A d d e n d u m

Iowa Department of Transportation
Office of Contracts

B.O.	Proposal ID	Proposal Work Type	County	Project Number	Addendum
102	21-0718-058	PCC OVERLAY - UNBONDED	CLAY	NHSX-071-8(58)--3H-21	17MAY102.A01

Replace plan sheets B.2, B.3, B.7, B.8, C.1, C.2, U.3, & U.5 with the attached:

TYPICAL HALF SECTION
TURN LANE FOR MILLING PRIOR
TO UNBONDED PCC OVERLAY

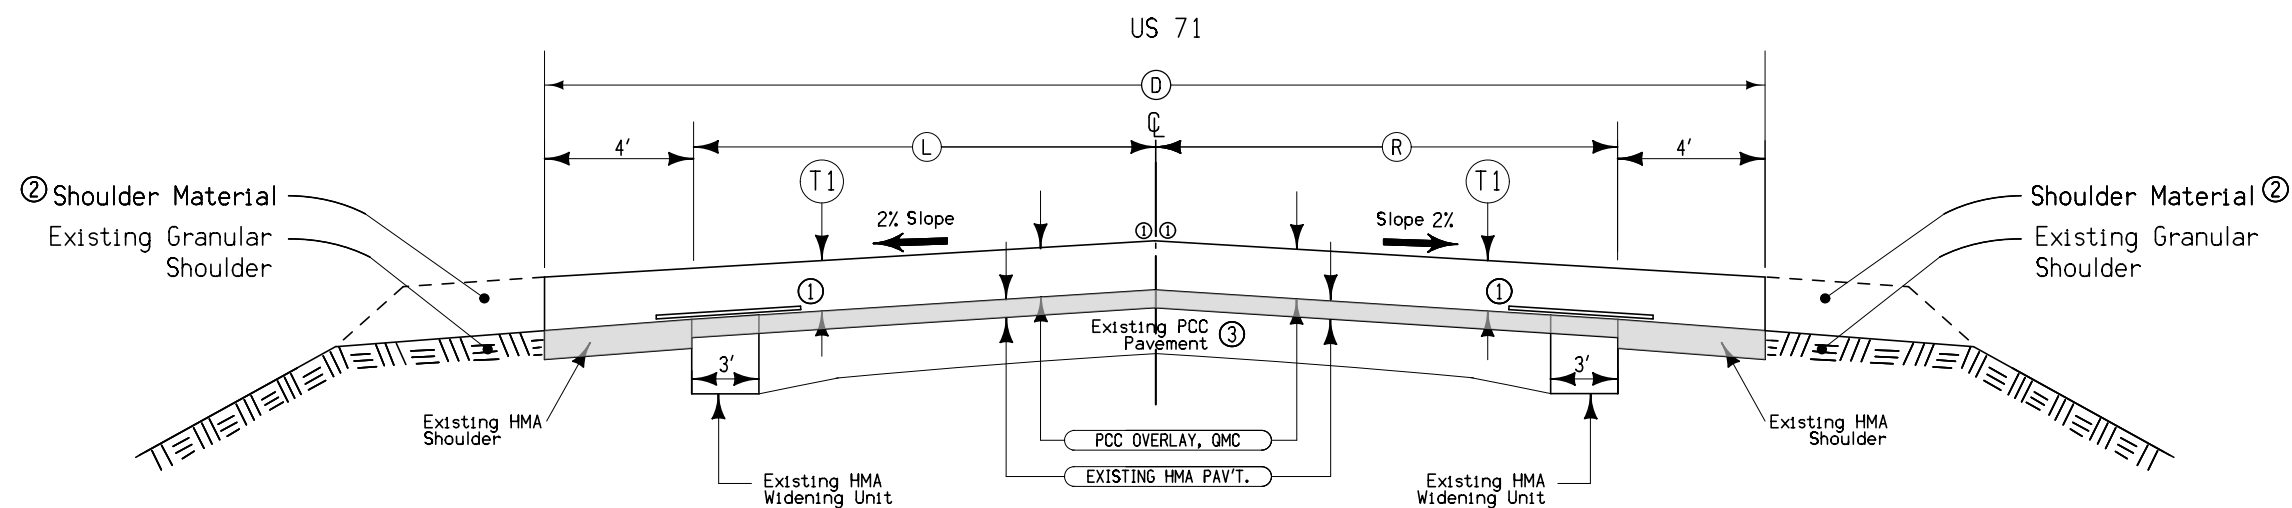
Sheet B.2, make the following changes to MIL-2:
ADD: US71/B53 STA 368+86, RT Milling = 17.9 Tons Blade & Shape 2.4 STA

TYPICAL HALF SECTION
TURN LANE
UNBONDED PCC OVERLAY

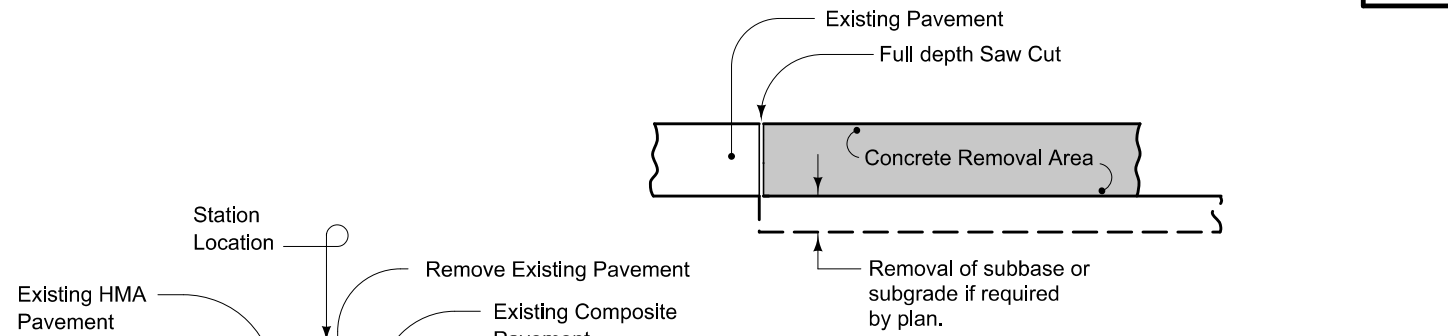
Sheet B.3, make the following changes to RTRN-1:
ADD: US71/B53 STA 368+86, RT PCC Overlay (Place) = 165 Sq.Yds. PCC Overlay
(Furnish) 27.5 Cu.Yds.

EX-JNT D
New

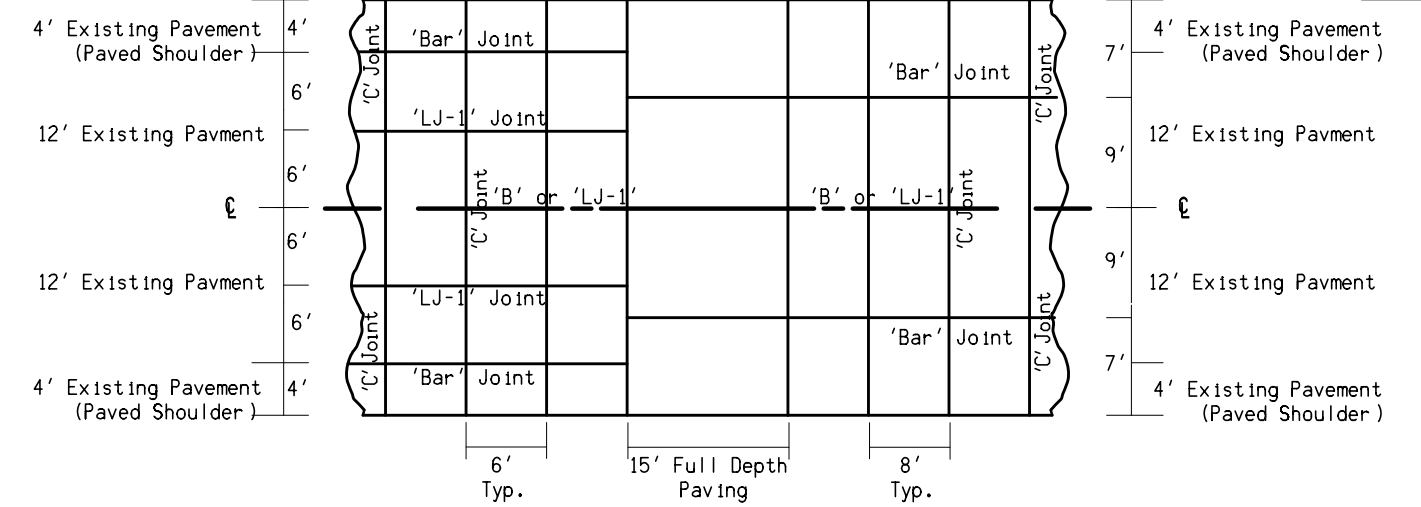
Sheet B.7, make the following changes to PAV-2:
Change the following reference note, Contract Items: PCC Overlay Place and Furnish:
From: 8.9 cy Furnish per site
To: 14.8 cy Furnish per site

Contract Items:
 Pavement Removal, (53.3 sy per site)
 Special Backfill, (18.9 tons per site)
 PCC Overlay Place and Furnish, (53.3 sy Place and 14.8 cy Furnish per site)

PCC PAVING OF TIE-INS AT PAVED SIDE ROADS

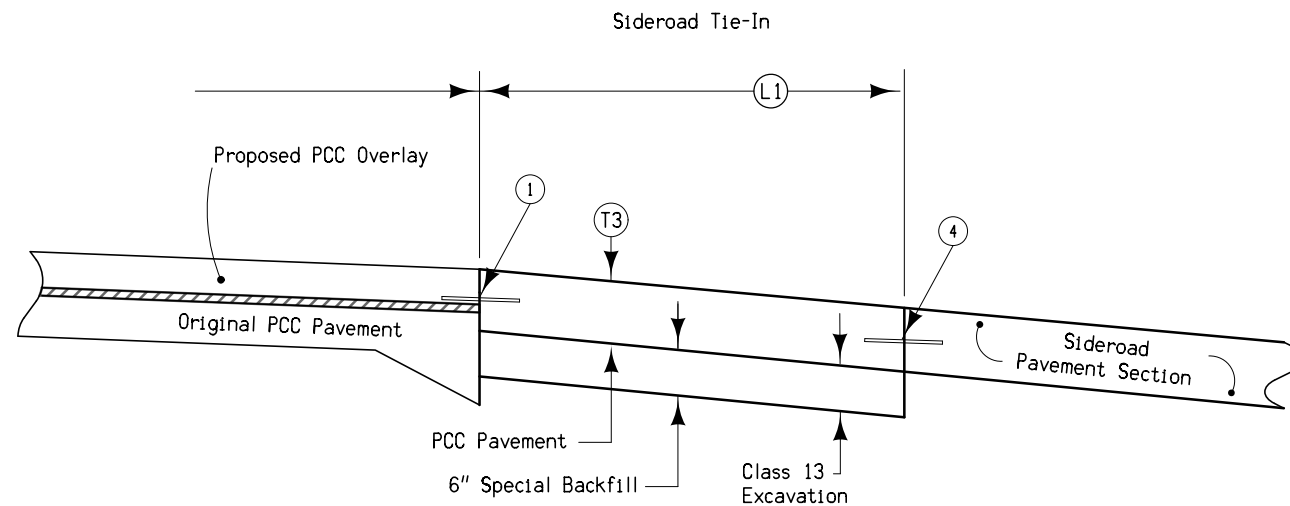
Sheet B.8, make the following changes to TIE4:

Change the following quantities at STA 370+24.00, LT:
10" Slip-Form Paving:
From: 721.3 Sq.Yds.
To: 741.0 Sq.Yds.

Special Backfill:
From: 242.2 Tons
To: 248.4 Tons

Class 13 Excavation:
From: 128.9 Cu.Yds.
To: 132.2 Cu.Yds.

Pavement Removal:
From: 721.3 Sq.Yds.
To: 741.0 Sq.Yds.

Change the following quantities at STA 370+24.00, RT:

10" Slip-Form Paving:

From: 722.3 Sq.Yds.

To: 788.7 Sq.Yds.

Special Backfill:

From: 242.5 Tons

To: 263.4 Tons

Class 13 Excavation:

From: 129.2 Cu.Yds.

To: 140.2 Cu.Yds.

Pavement Removal:

From: 722.3 Sq.Yds.

To: 744.7 Sq.Yds.

ROAD IDENTIFICATION	Location Station	Side	Ⓣ3 Inches	Ⓛ1 Feet	Design Quantities Per Location									Comments
					PCC, QMC (PLACE) Sq. Yds.	PCC, QMC (FURNISH) Cu. Yds.	Standard/Slip-Form PCC Paving, 10" Sq. Yds.	Special Backfill Tons	Class 13 Excavation Cu. Yds.	Embank-In-Place Cu. Yds.	Earth Shoulder Finishing Sta.	Granular Shoulder Tons	Pavement Removal Sq. Yds.	
					US 71	56+74	LT	10	24	0	0	462	160.5	
US 71	370+24	LT	10	50	0	0	741.0	248.4	132.2	0	0	0	741.0	B53 West Half
US 71	370+24	RT	10	50	0	0	788.7	263.4	140.2	0	0	0	744.7	B53 East Half

FILE NO.	ENGLISH	DESIGN TEAM	DISTRICT 3	CLAY COUNTY	PROJECT NUMBER	NHSX-071-8(58)--3H-21	SHEET NUMBER	U.5
----------	---------	-------------	-------------------	-------------	----------------	------------------------------	--------------	------------

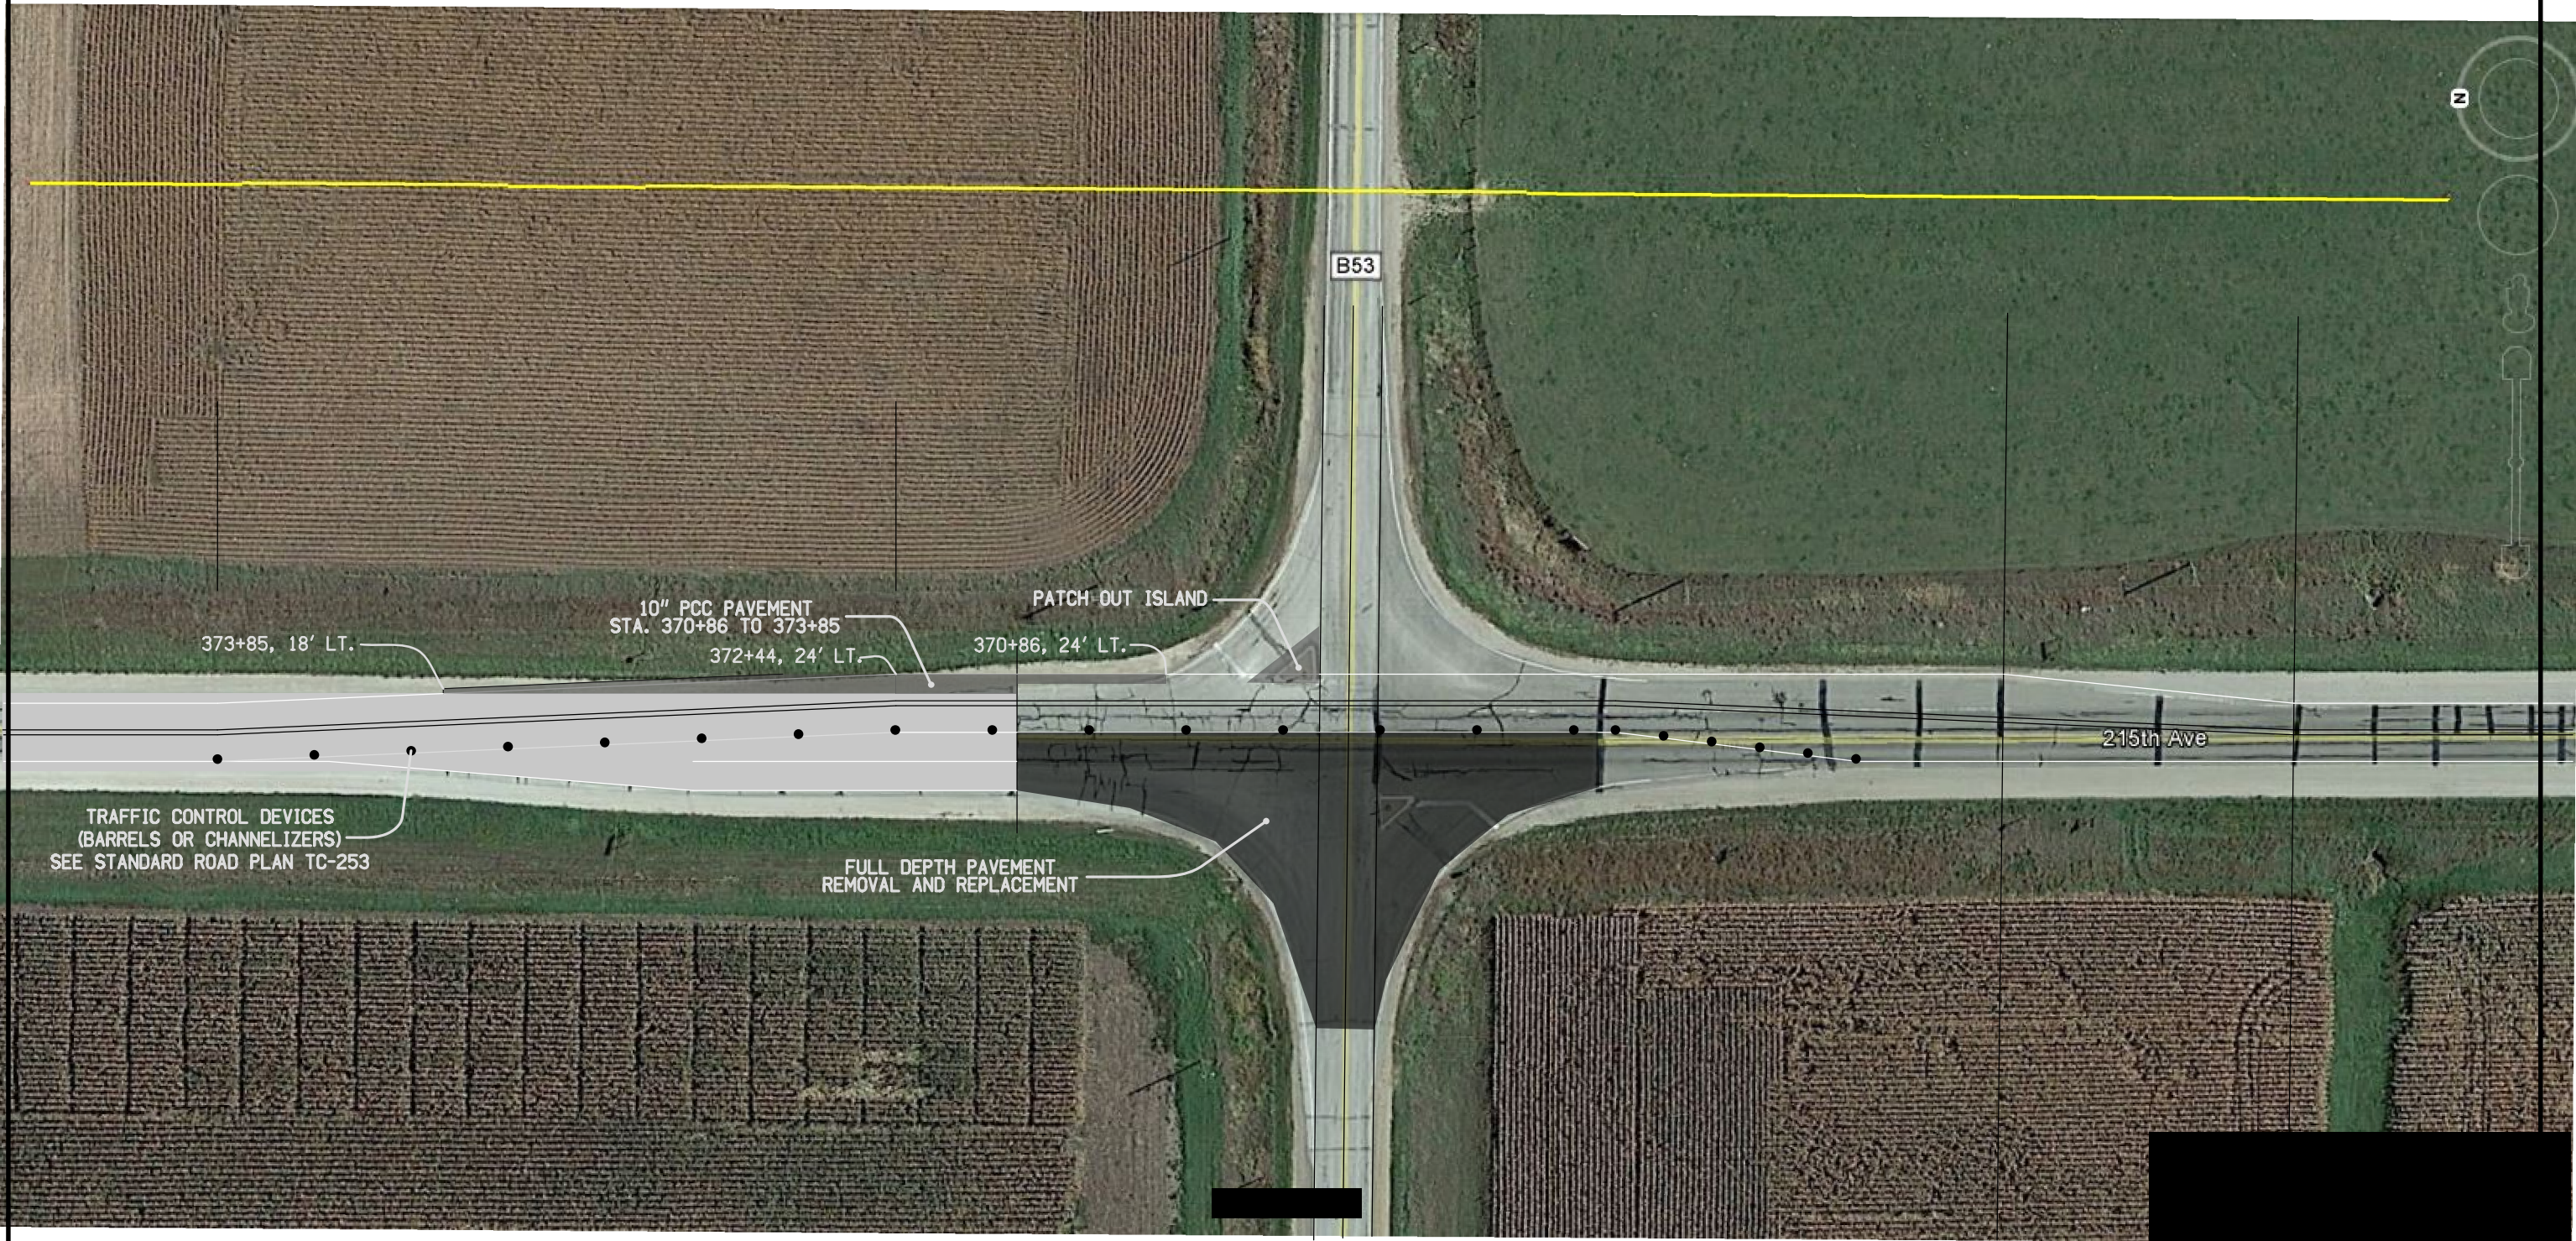
Replace sheet U.5.
